COMMENTS

Applicant : David B. Miller
Serial No. : 09/688,064
Filed : October 13, 2000
Page : 10

Attorney's Docket No.: 10001197-1

FIG. 6A

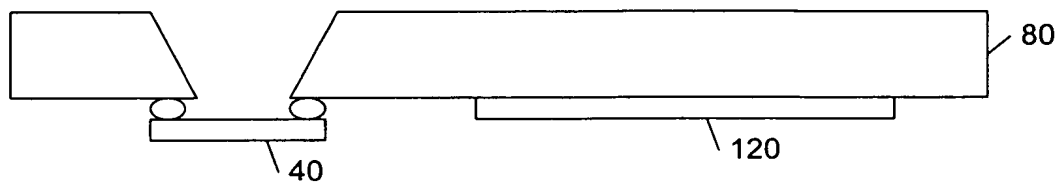
FIG. 6A has been amended in response to the Examiner's objection under 37 CFR 1.83(a). In particular, FIG. 6A has been amended to show diagrammatically that the integrated circuit 120 is formed on spacer substrate 80.
